Addendum #2

Date	Owner Property Number	Owner Building Number	BHDA Project Number
Fri, 22 Jun 2018	505-1975	Orem UT South FM Group Building #20	1822

Project Designation	Project Address
Cherry Hill 1, 2, 4 Mother's Room Orem UT Cherry Hill Stake	1700 South 400 East Orem, Utah 84058

MAIN FLOOR FRAMING PLAN \bigcirc — 3/16"=1'-0"

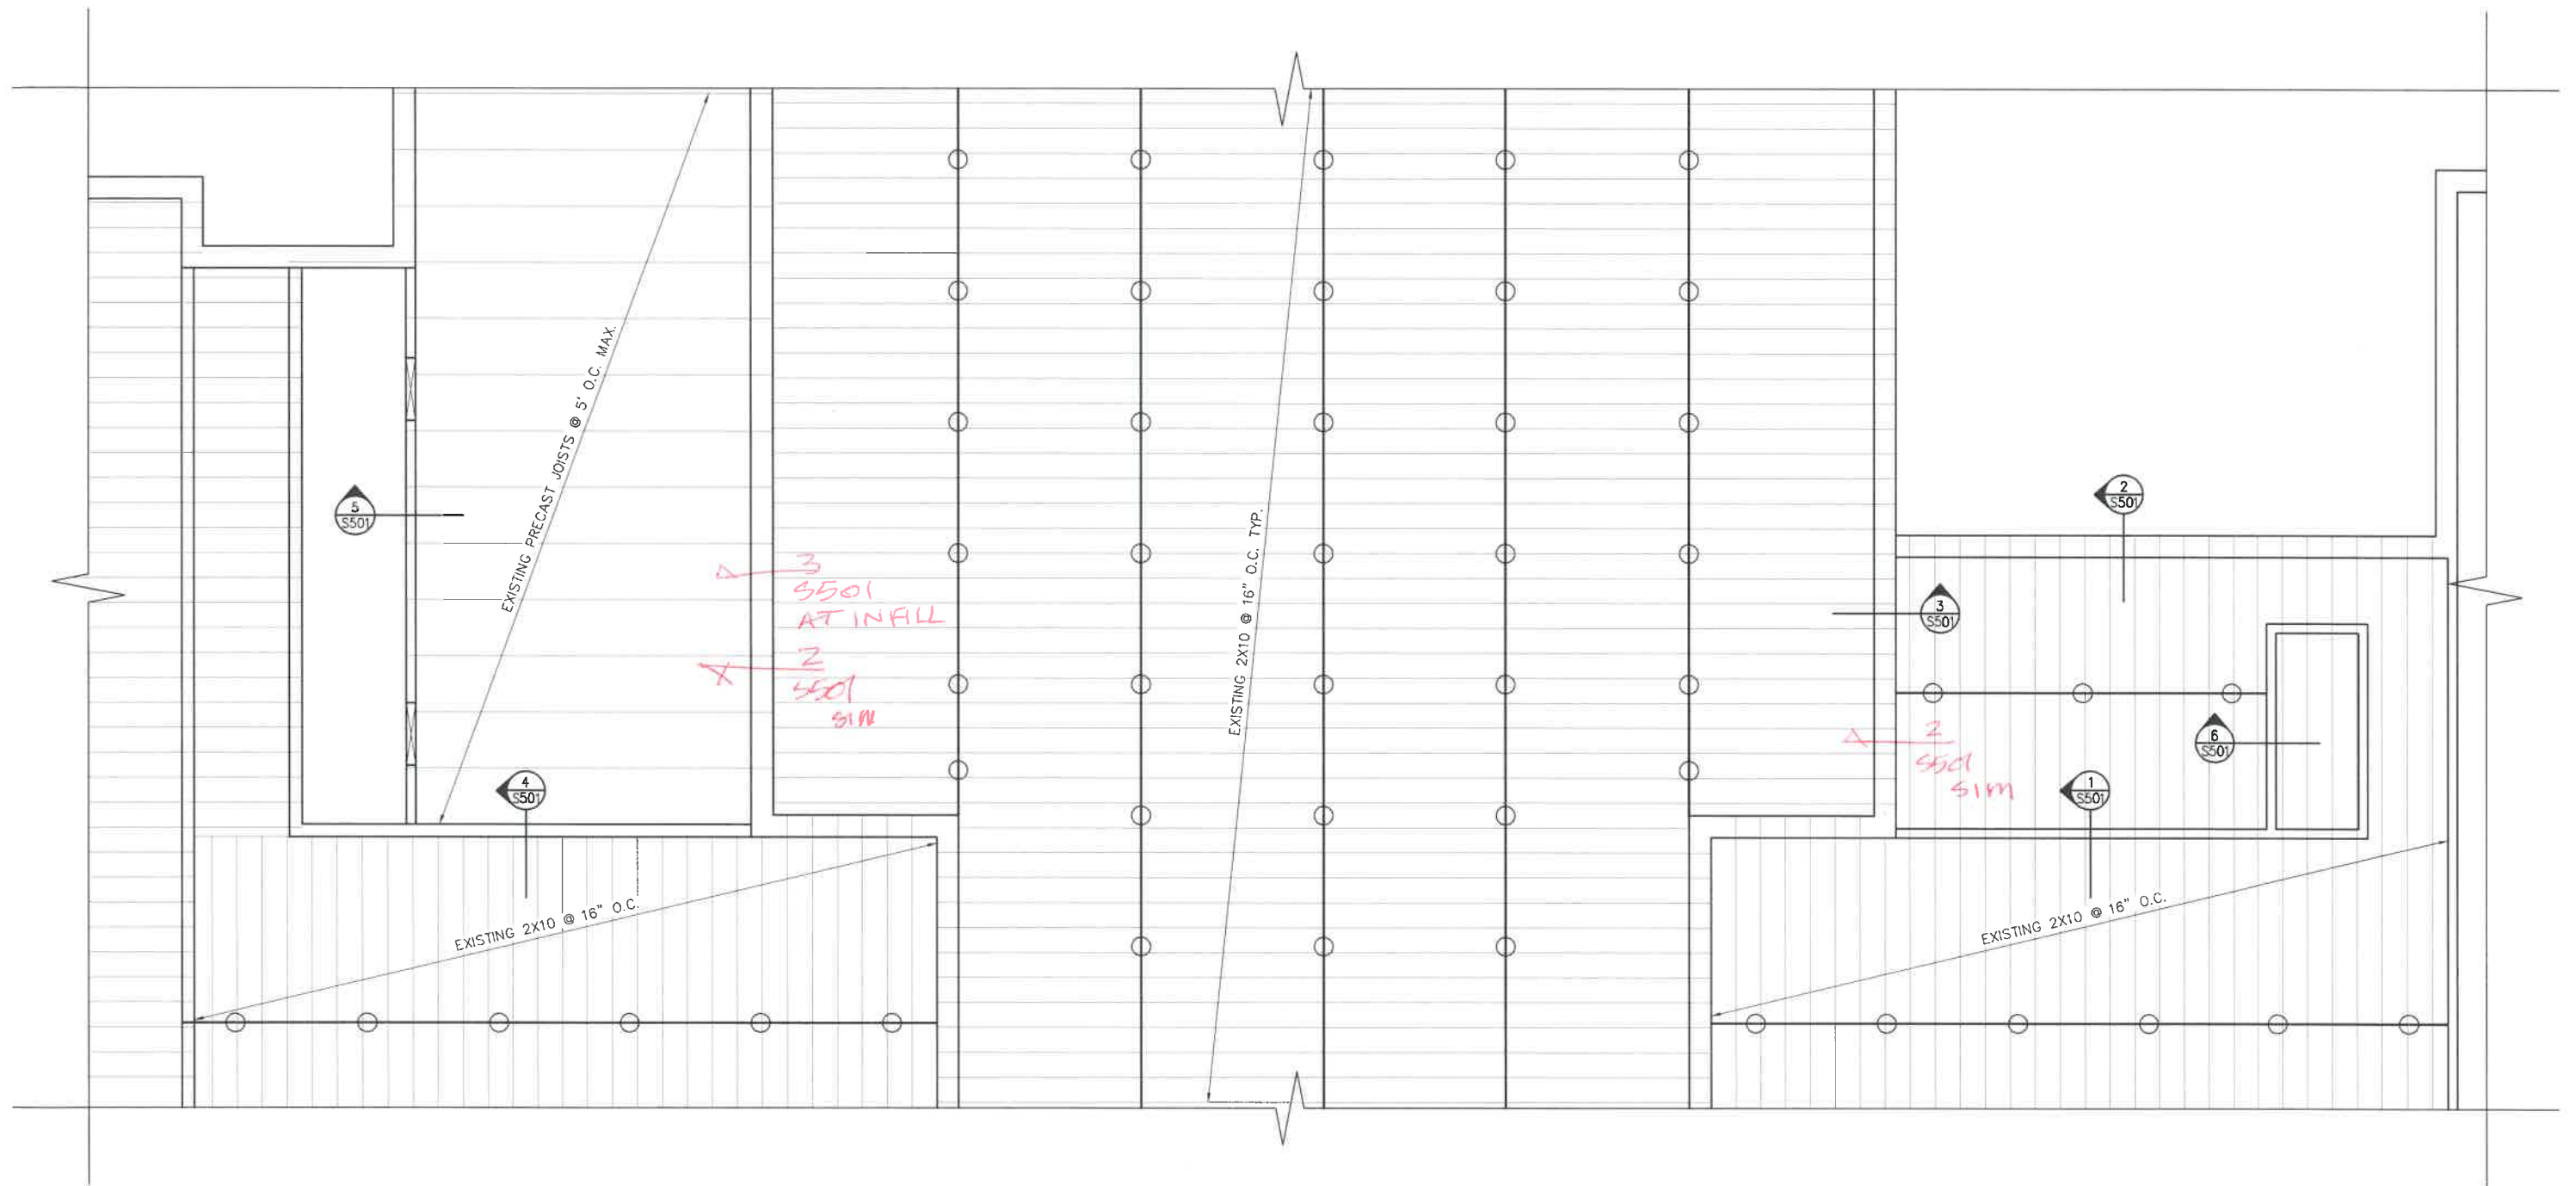
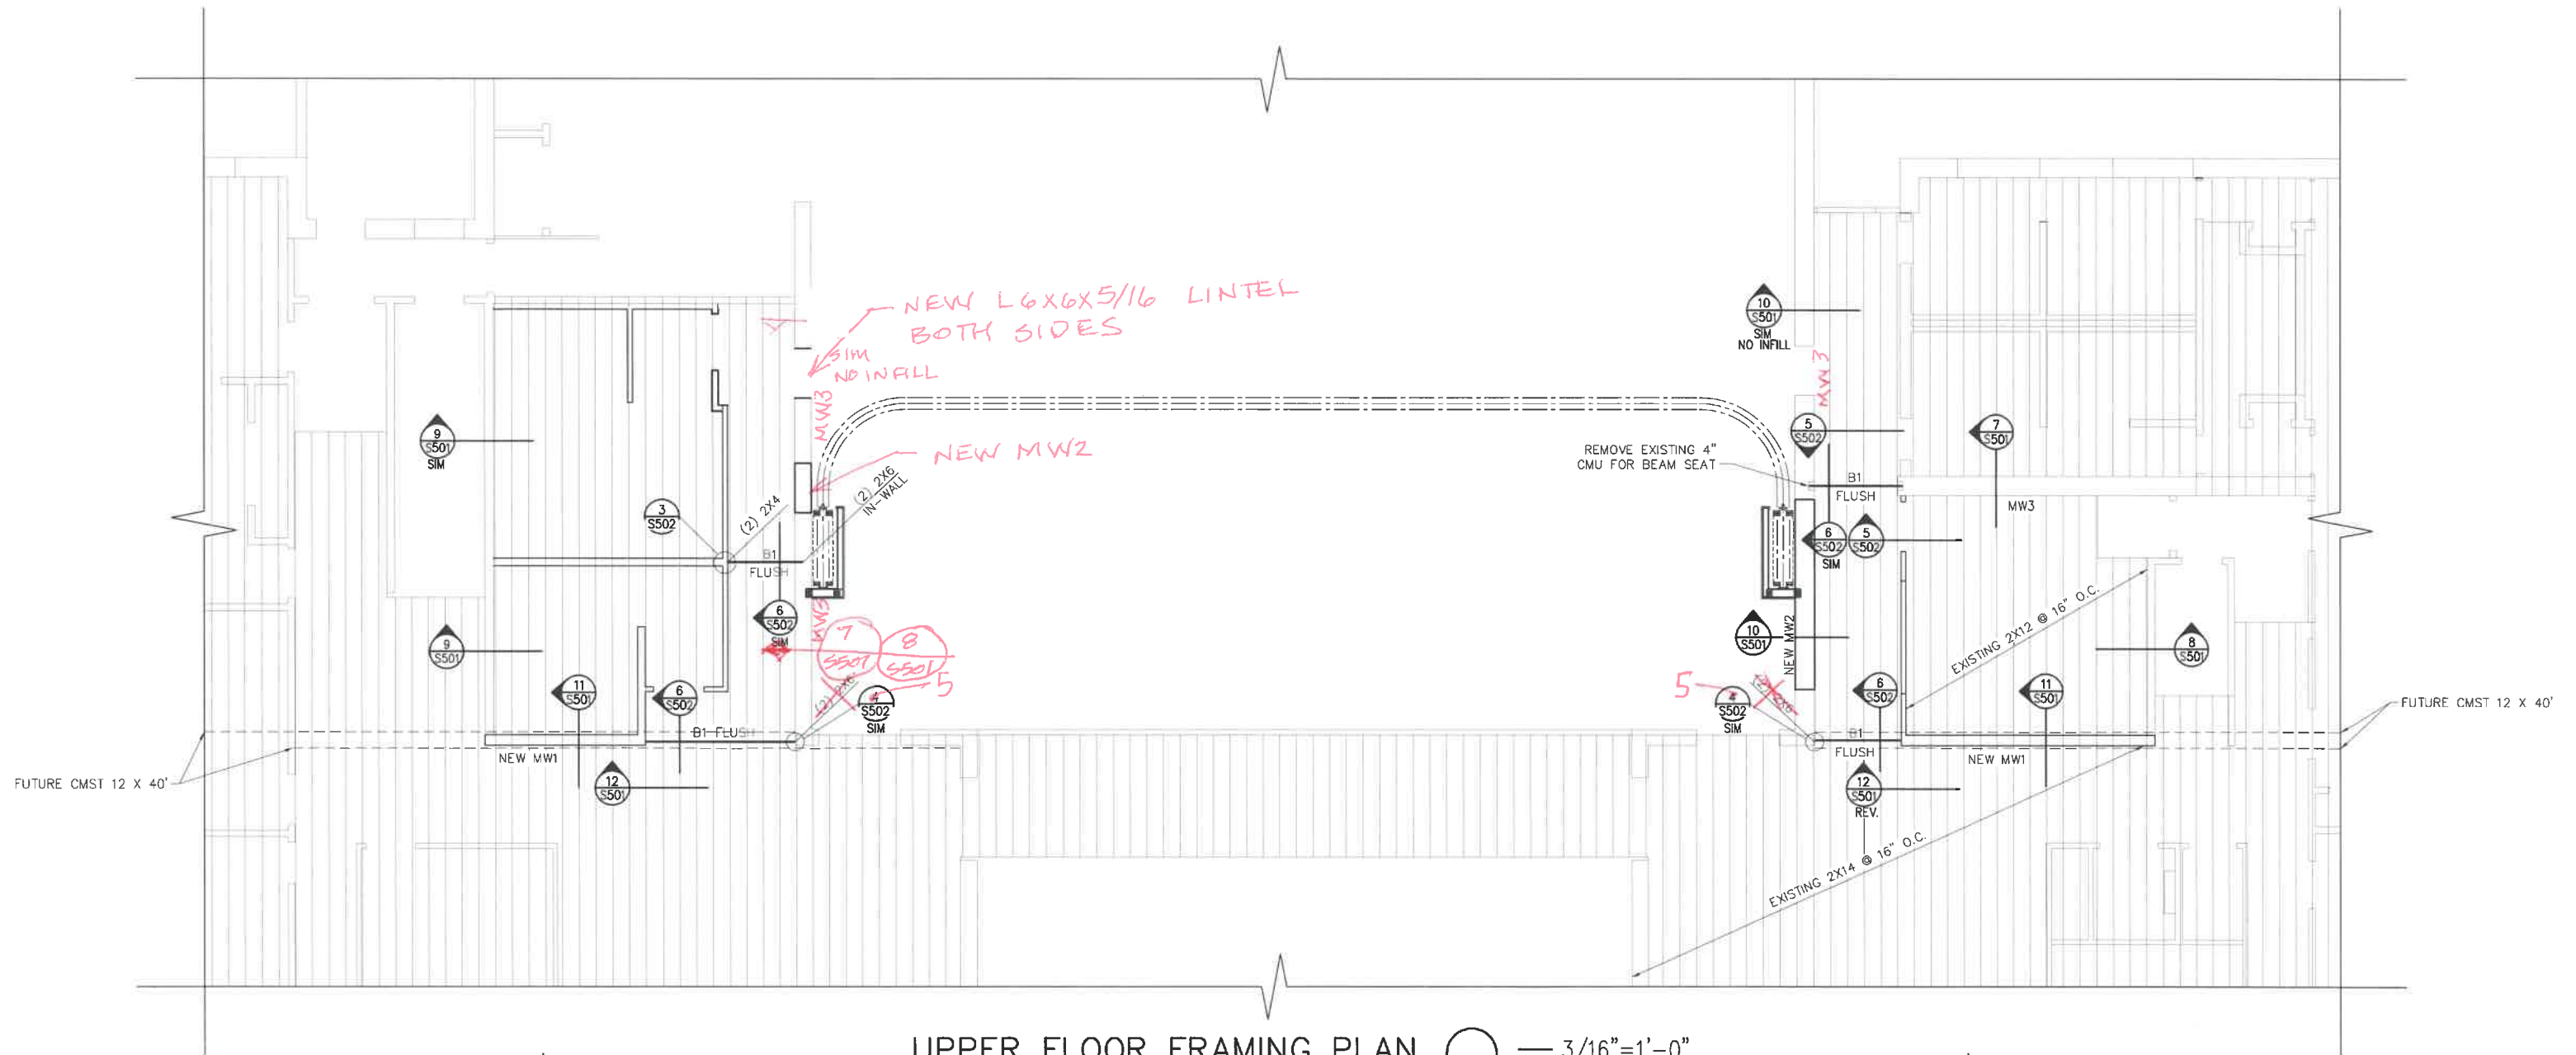
4.02. Structural Items

- A. See the attached redlines for updates to the plans, including the following:
 - 1. Wall between the Cultural Hall and new restrooms is masonry. Wall needs to be chased on the restroom side main floor level only. See MW3 on the masonry wall schedule.
 - 2. Infill the man-door that is near the folding partition stacking area with masonry. See MW2 on the masonry wall schedule.
 - 3. Wall anchors will be needed to attach the second floor framing to the masonry walls, as with other masonry walls in the project area. Details have been keyed in on the attached plan.
 - 4. New B1 beams will require the bracket shown on Detail 5/S502 for support at the masonry walls. Delete the (2)2x6 columns shown.
 - 5. Floor joists over the remodeled restroom area are running the opposite way from that shown on the plans.
